BEFORE THE OHIO POWER SITING BOARD

In the Matter of the Application of	)	
Blossom Solar, LLC for a Certificate of	)	Case No. 22-151-EL-BGN
Environmental Compatibility and Public	)	
Need	)

NOTICE OF FILING RESPONSES TO STAFF DATA REQUESTS

**Blossom Solar, LLC's June 22, 2022 and July 11, 2022 Responses to Staff's June 21, 2022,
and June 28, 2022 Data Requests**

BLOSSOM SOLAR SITE PLAN

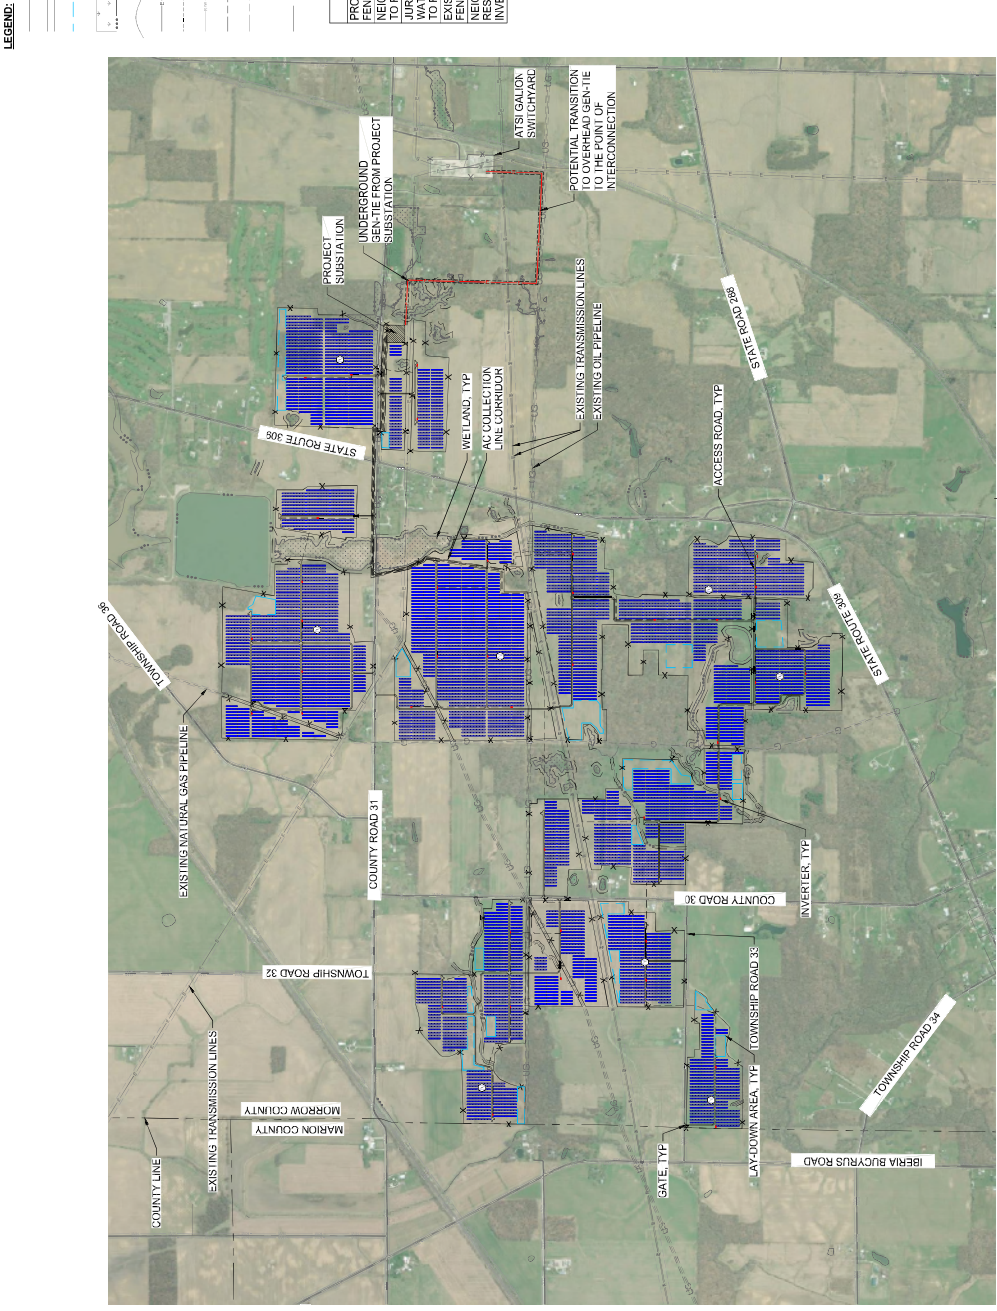
15. Blossom Solar, LLC seems to indicate that the gen tie transmission line is still under design. Please provide the 10% design or better (i.e., overhead plans, transmission line plan and profile view) for the gen tie transmission line.

- 16. Page 9 of the Application indicates that the gen-tie will be mostly buried. Please further explain what length of the gen-tie line would be buried and delineate on Figure 2 (Map of Aerial View of Project Area) the portion of the gen-tie line that would be underground.**

Response: See response to question #12, the Preliminary-Maximum Site Plan provided as Exhibit A to the Application, and a revised page CS100 of the Preliminary-Maximum Site Plan that is provided as Attachment 5.

Response: See answer to Question 12. The revised page CS100 of the Preliminary-Maximum Site Plan (Attachment 5) includes a call-out box and arrow showing the portion of the gen-tie that may be overhead. The revised page CS100 shows that at least approximately 4,218 feet of the gen-tie—starting from the project substation until it reaches FirstEnergy’s property—will be buried. At this point, as shown on the revised page CS100, approximately 1,350 feet will either be buried or overhead until it reaches the fenceline of the switchyard.

Figure 1 – Wind Speed Percentages at MNN and MFD from 2017 to 2022

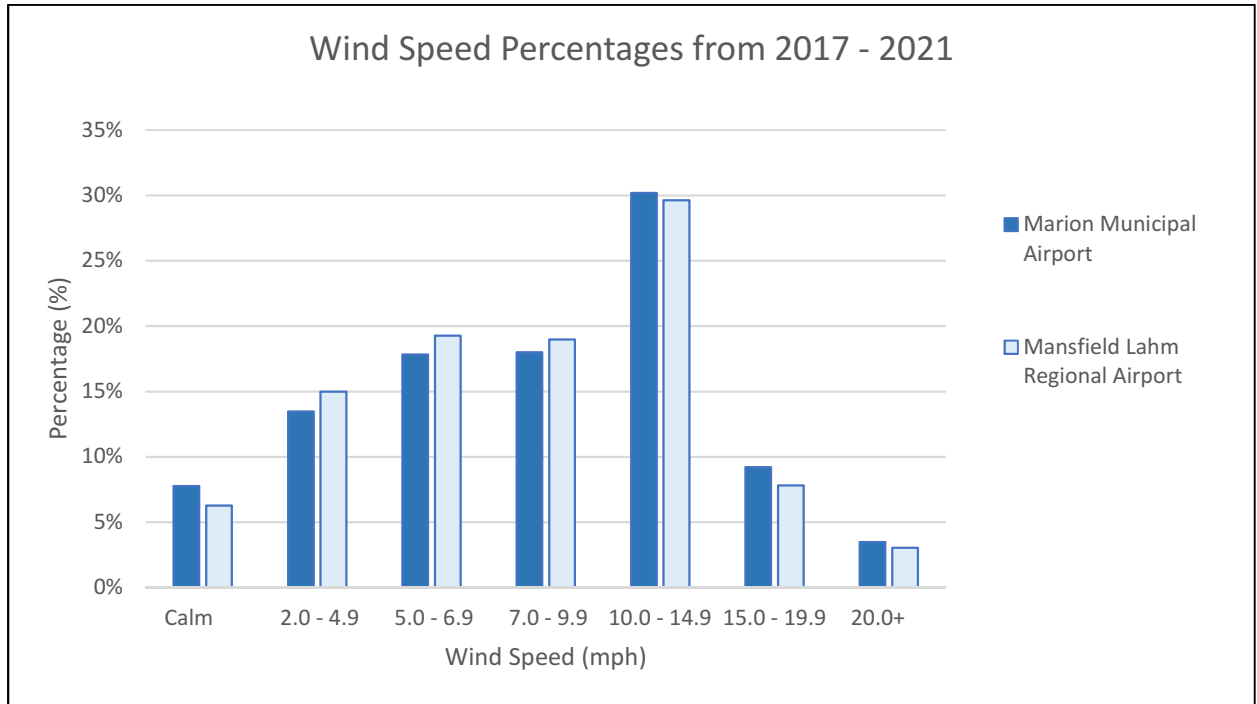
32. Provide the range of wind velocities that have been experienced and would be expected to be observed in Blossom Solar Project’s project area Morrow County, along with the probabilities or probability distribution for these velocities.

Supplemental Response: *As discussed in the response to Question #31, the nearby MNN and MFD airports both have complete meteorological data sets and are representative of wind speeds at the project site. Wind speed ranges and percentages for these meteorological stations from 2017 to 2021 are shown in Figure 1.*

*As shown in the above figure, wind speed distributions at MNN and MFD are similar and are representative of winds at the project site. Wind speeds in the 10-15 mph range are most common, with winds in the 2 to 10 mph range being the next most frequently occurring. Wind roses for MNN and MFD, which depict both the frequency and direction of winds, are included in **Attachment 2**. The dominant wind direction in the project area is blowing from the southwest.*
